RECALL: This modification has top priority and must be performed immediately to ensure customer safety

Subject: Factory Direct Modification Campaign – Handlebar Clamp Replacement on all affected models listed below

Affected 2011 Models: FE 570 S, FS 570

Photo A

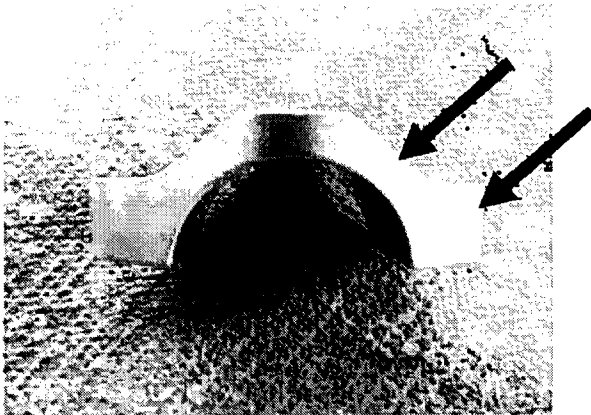
- » It has been determined that the cause of the defect is from variations in the material quality and the heat treatment process at the supplier of the handlebar clamps. To remedy this defect the replacement handlebar clamps are milled from billet material and have been reinforced in some areas. It is required that both handlebar clamps be replaced at the same time.

Photo A, part # 772 01 038 000, reinforced areas.

- » Replace the handlebar clamps with the new version, Part # **772 01 038 000**, on all vehicles that you have delivered to your customers and on vehicles in your inventory. Be sure to properly torque all four mounting bolts to 20Nm/14.8lbs.ft.

Photo B

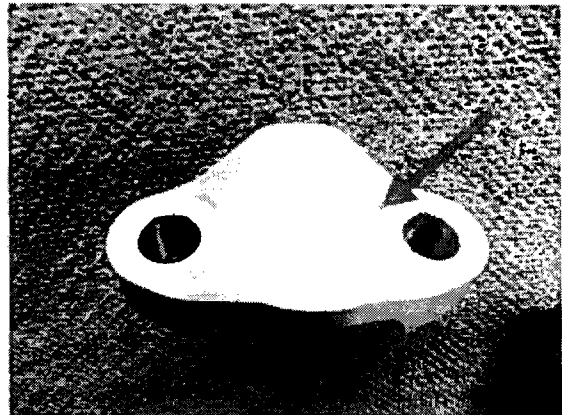
Photo B, handlebar clamp has a punch dot clearly marked to identify new part.

Inspection: Carefully inspect each handlebar clamp (photo B) for the appropriate punch dot, as shown in the photo above. If the handlebar clamps have the appropriate punch dot the proper handlebar clamps are installed.
